STANDARD DEPARTURE CHART - INSTRUMENT

RJNH / HAMAMATSU

SAGRA FIVE DEPARTURE

ATSUMI FIVE DEPARTURE

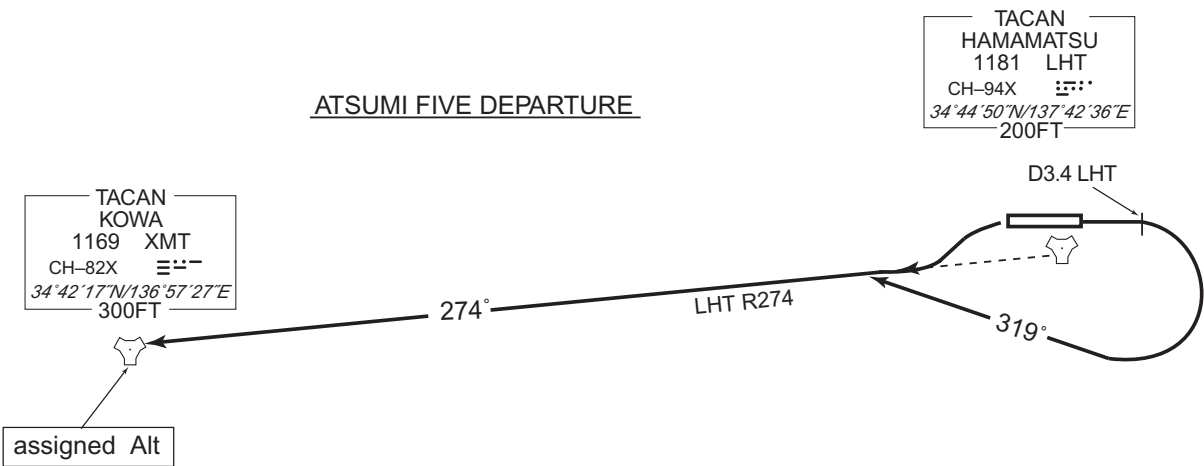
CHANGE : PROC renamed. PROC course. Note deleted.

HAMAMATSU REVERSAL THREE DEPARTURE

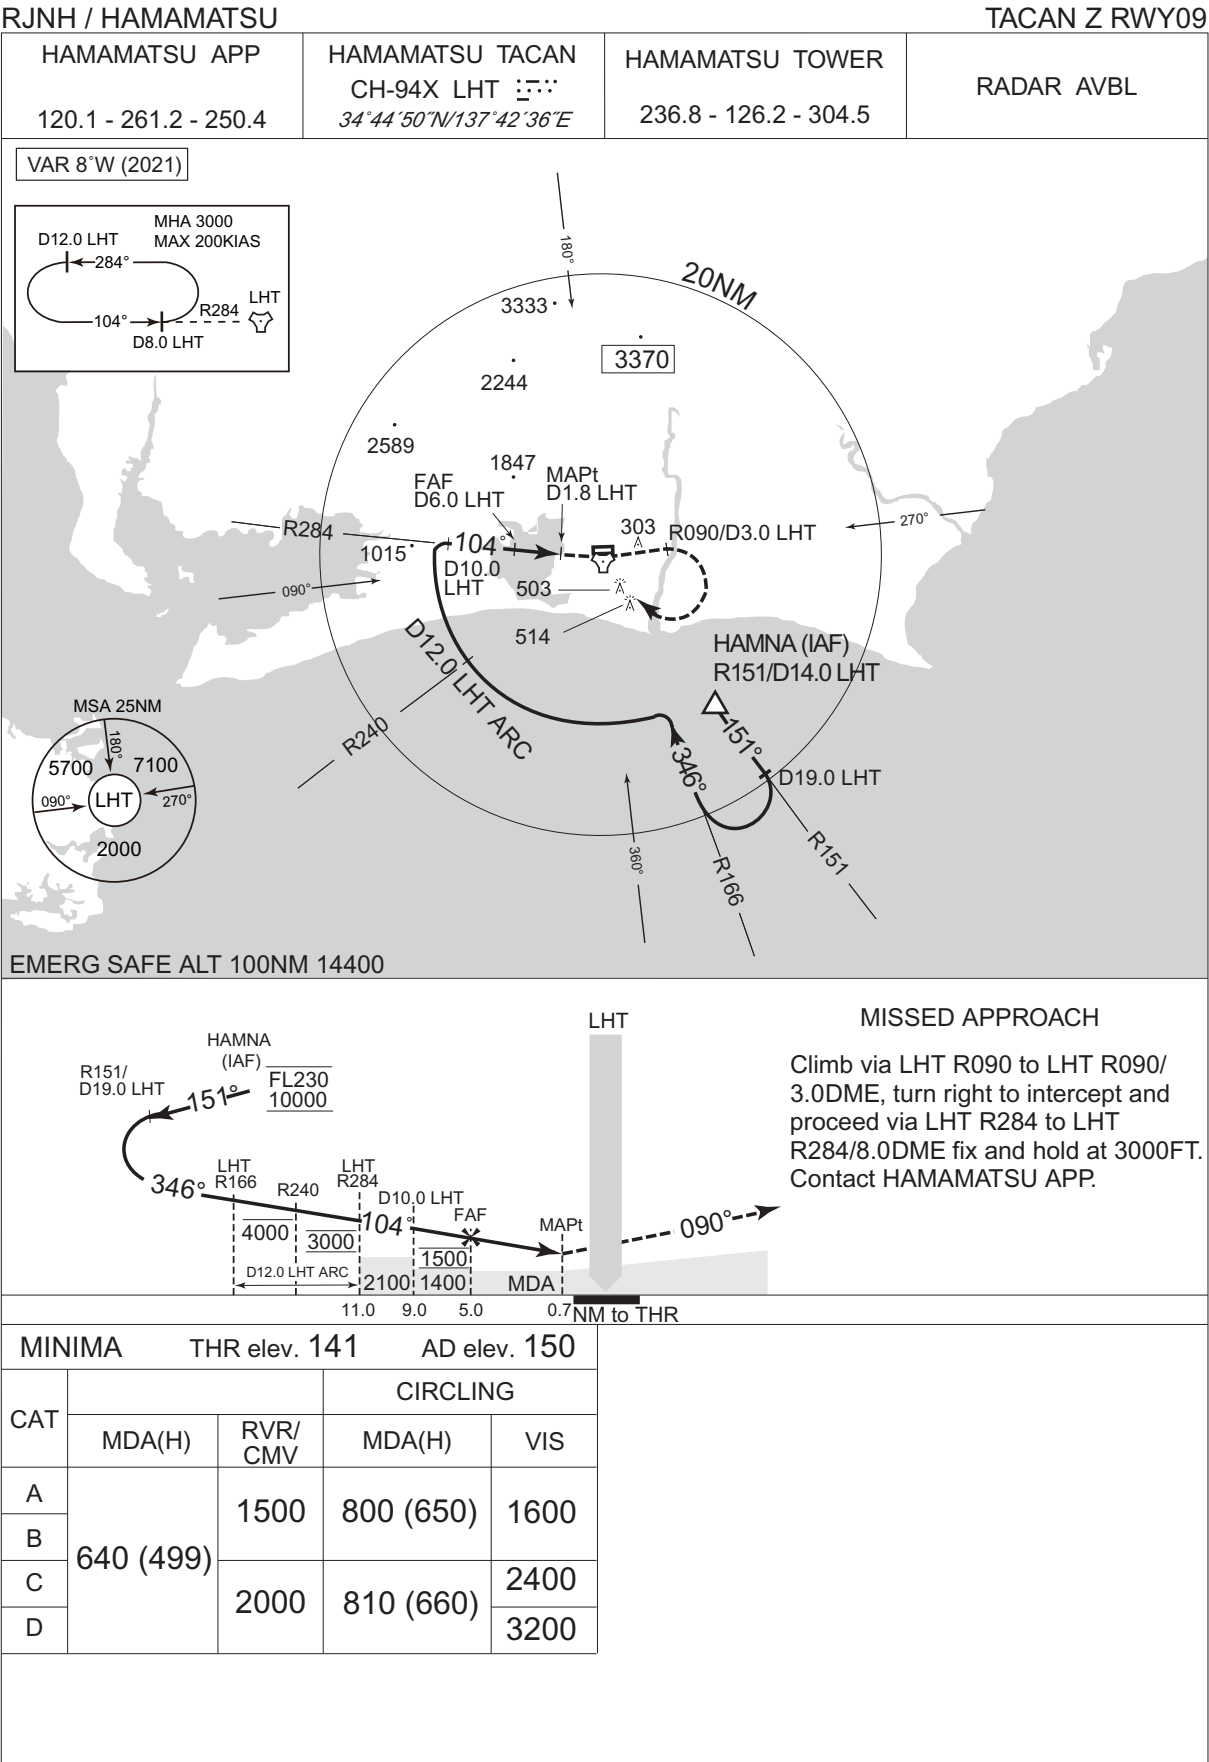
CHANGE : PROC renamed. PROC course. Note deleted.

TACAN Y RWY09

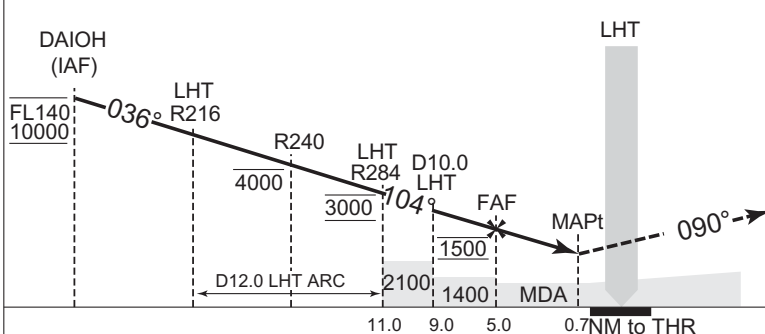
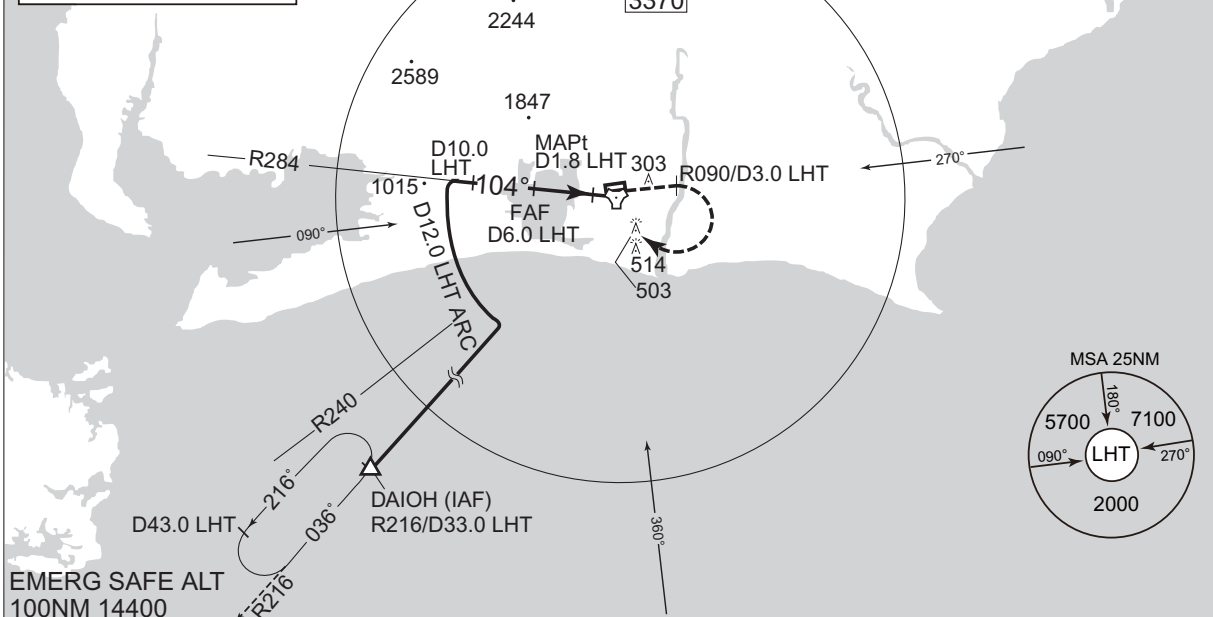
CHANGE : VAR. PROC renamed. PROC course. Description of FAF, MAPt added. OBST added(HGT 303).
OBST deleted(HGT 410, 504). MISSED APPROACH course. ALT restriction(DAIOH). OCA/H added. MDA(H) for CIRCLING.

TACAN Z RWY27

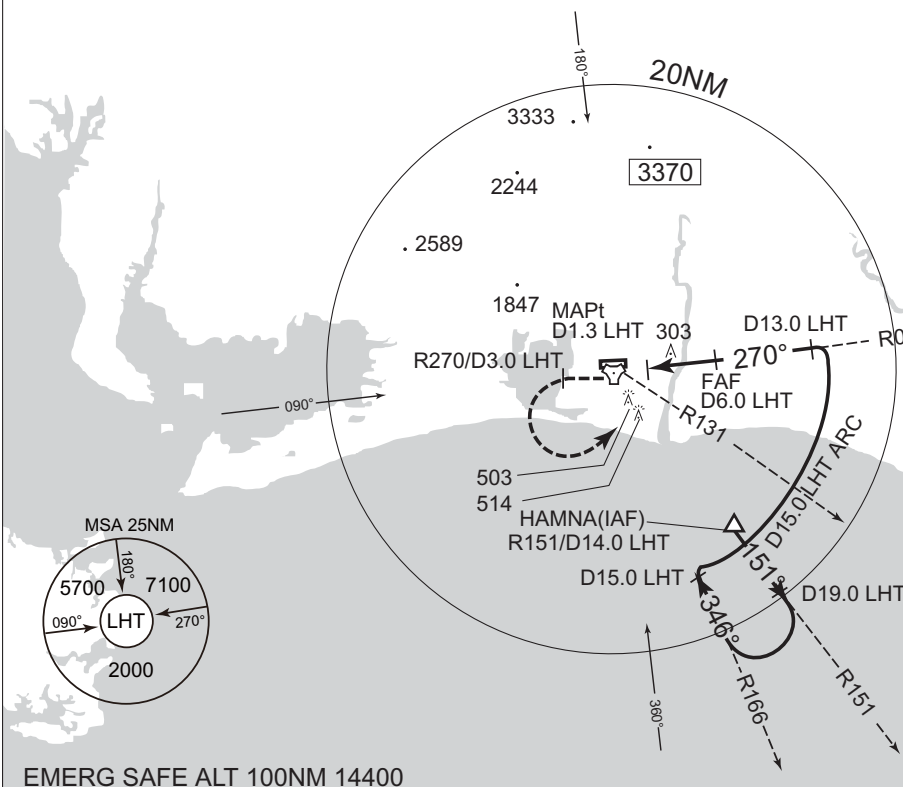
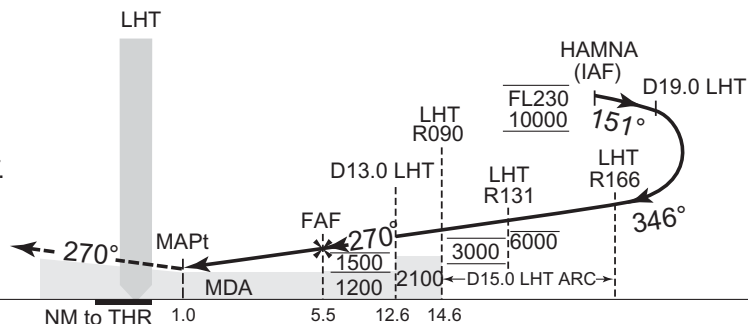
CHANGE : VAR. PROC renamed. PROC course. Description of FAF, MAPt added. OBST added(HGT 303).
OBST deleted(HGT 410, 504). MISSED APPROACH course. ALT restriction(LHT R090). OCA/H added. MDA(H). MDA(H) for CIRCLING.

TACAN Y RWY27

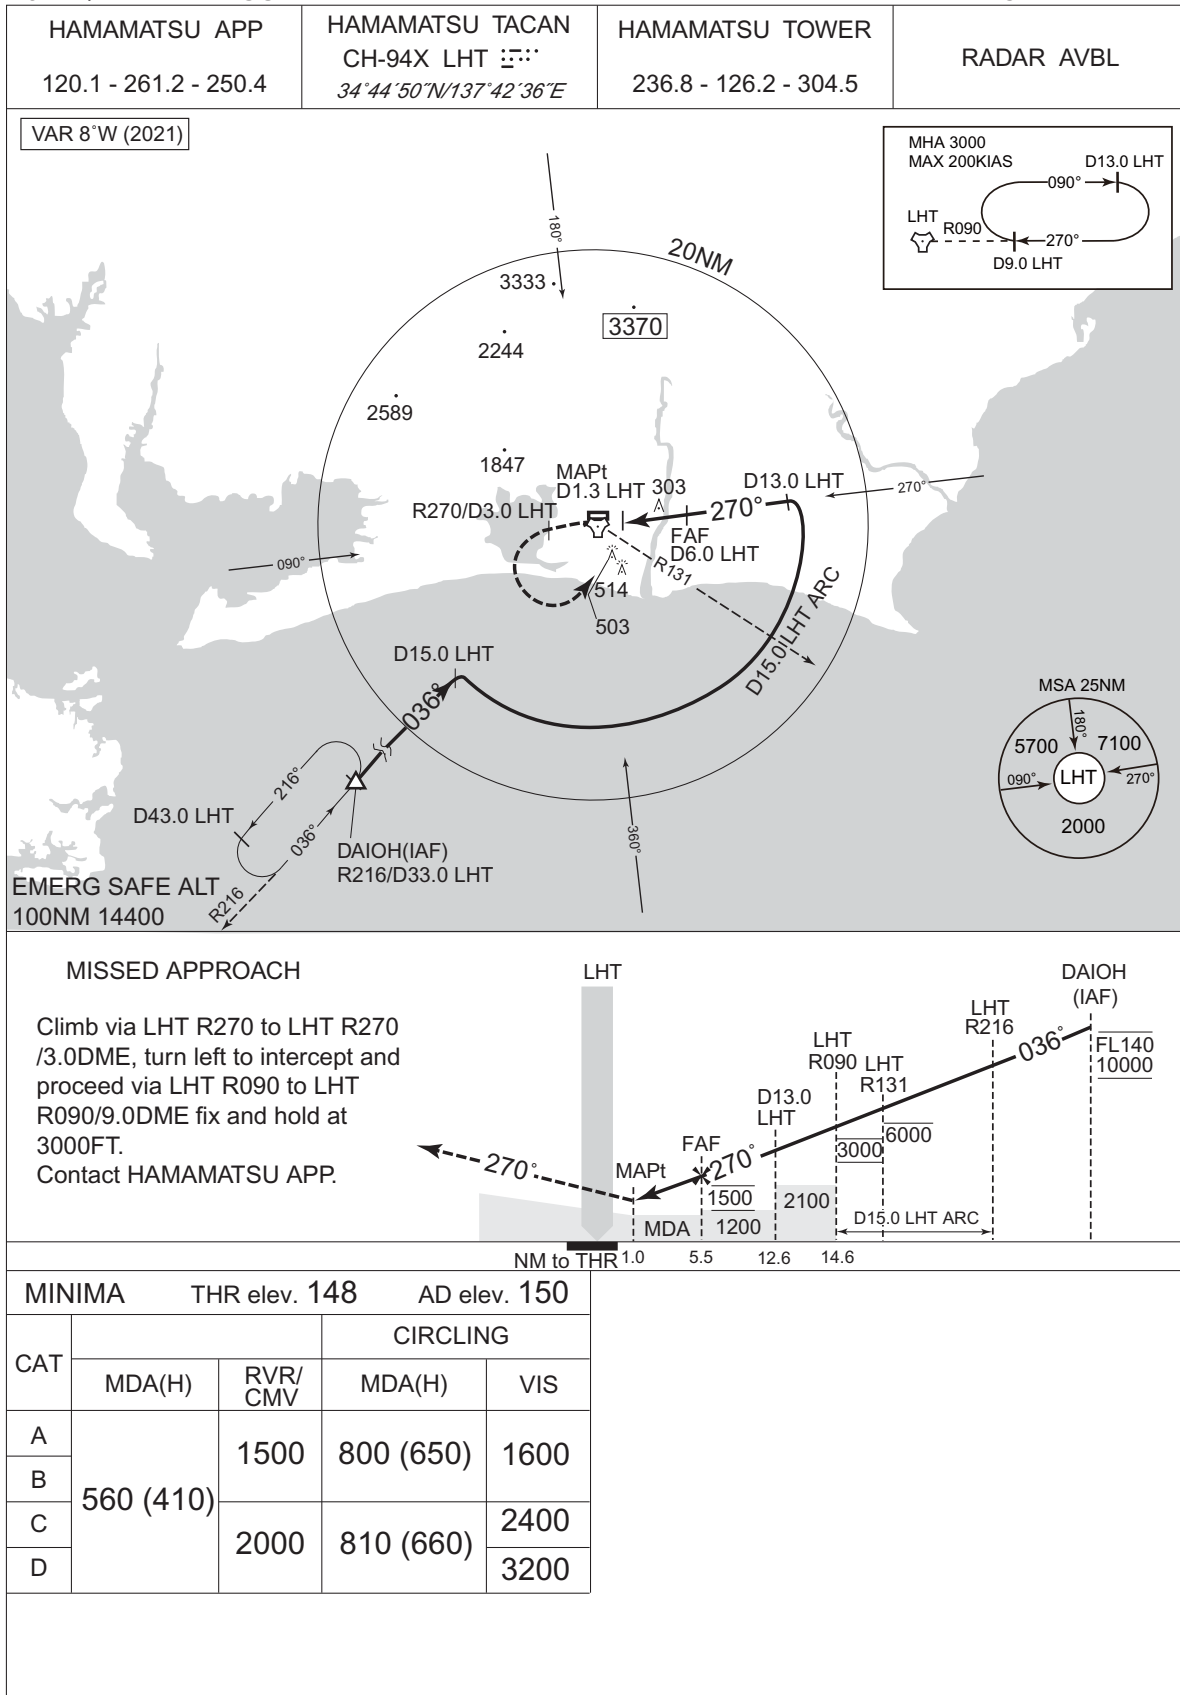
CHANGE : VAR. PROC renamed. PROC course. Description of FAF, MAPt added. MSA. HLDG pattern added. OBST added(HGT 303). OBST deleted(HGT 410, 504). MISSED APPROACH course. ALT restriction(DAIOH, LHT R090). OCA/H added. MDA(H). MDA(H) for CIRCLING.
